Groundwater Application Review Summary Form

Application # G- 19424

GW Reviewer Joe Kemper Date Review Completed: 8/13/2024

SUBJECT: Scenic Waterway Interference & General/Local Surface Water
Evaluation for Deschutes Ground Water Study Area

Hydrograph One: Water level records for wells near Sisters. The change in water level elevation corresponds to traces of the Sisters Fault Zone and associated geologic structure.

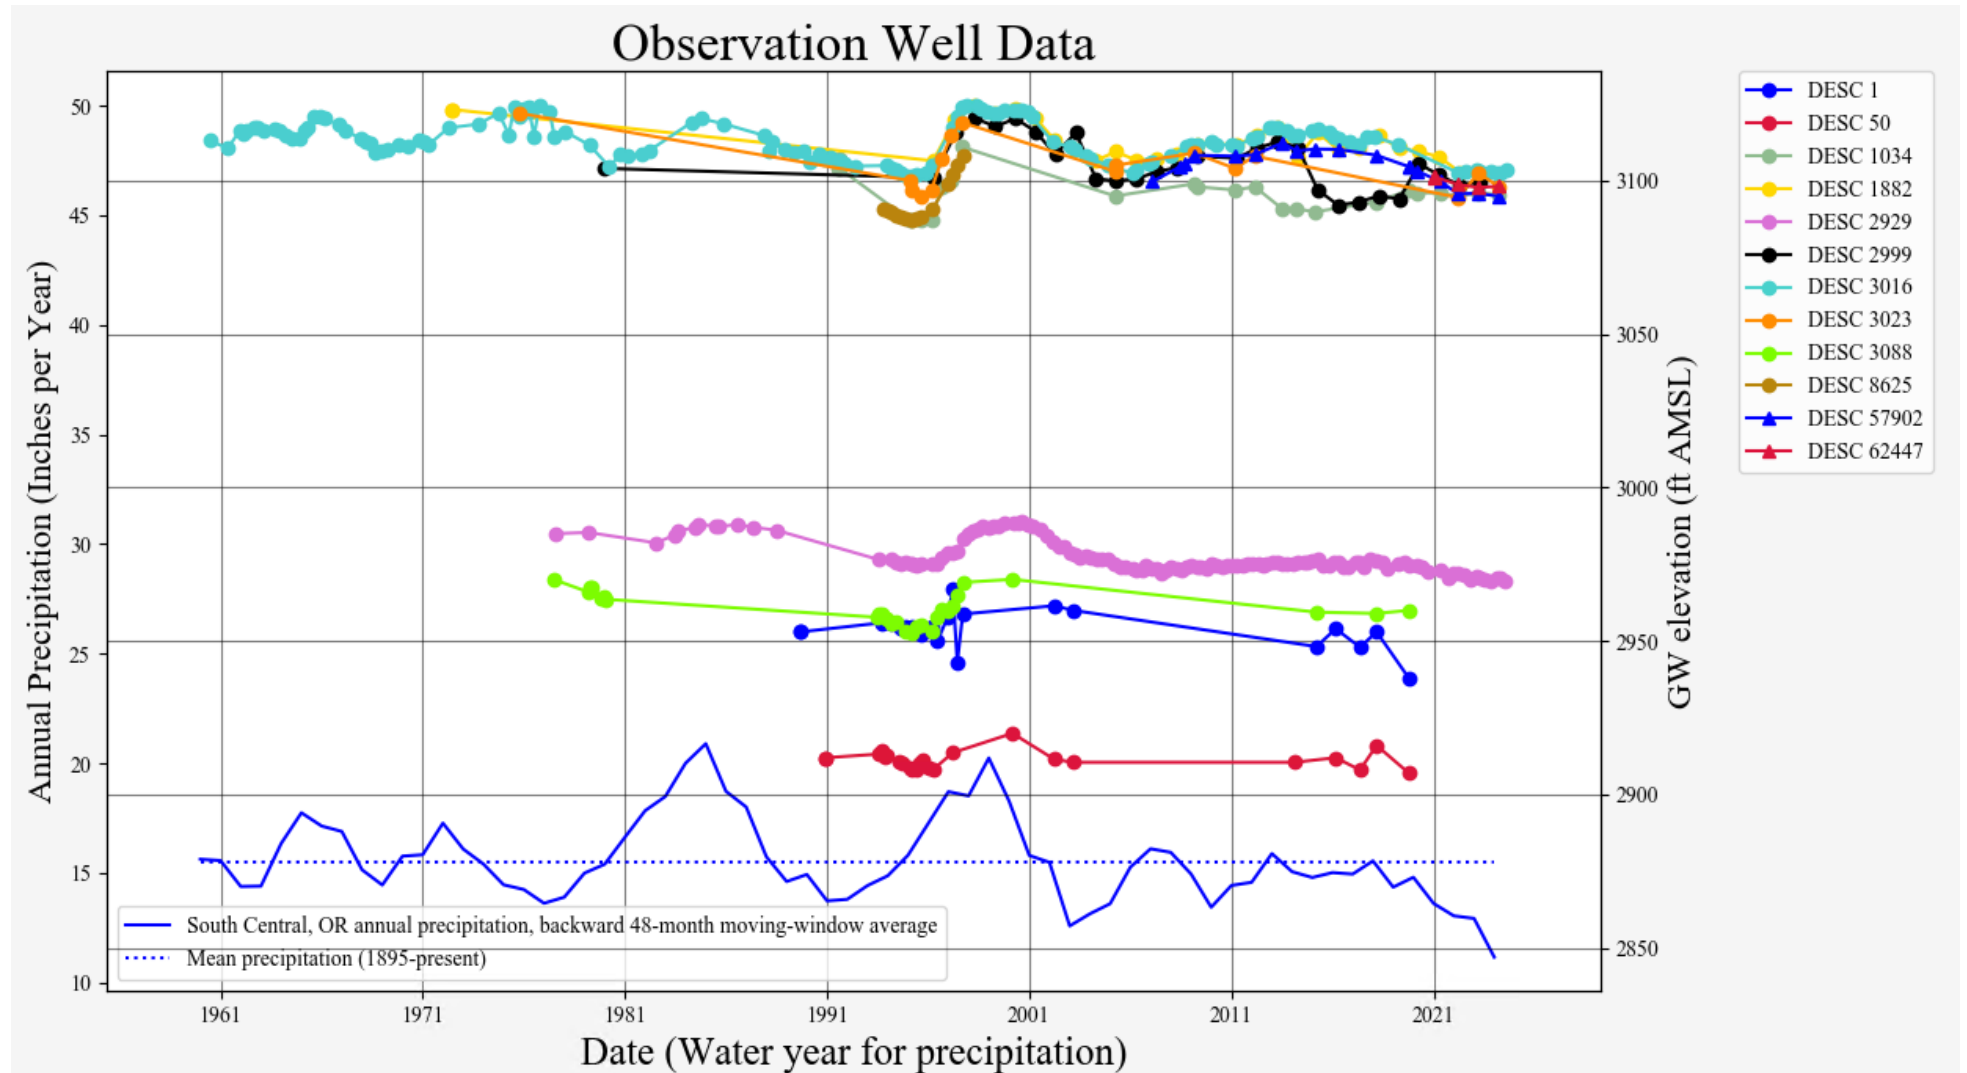
- B3. **Groundwater availability remarks:** The applicant's wells access the Deschutes regional aquifer where it is hosted by glacial outwash sediments and underlying/interbedded volcanics from the Cascades. Hydrograph one below shows a change in water level elevation that is coincident with traces of the Sisters Fault Zone and associated geologic structure. Upgradient (west) of the SFZ extent, water levels are approximately 3090-3120 feet AMSL. DESC 3016 has the longest record of the target aquifer zone, which appears to be in dynamic equilibrium with decadal scale climate fluctuations. Assuming that those decadal scale wet-dry periods will continue, water levels at this location will likely recover from their current lows with the onset of wetter-than-average years. At present, the target aquifer in this location does not have persistent year-on-year declines that raise issues of capacity of the resource issues elsewhere in the basin. It is noted that DESC 3016 also shows longer term declines that may reflect century-scale climate trends that are not as well documented.
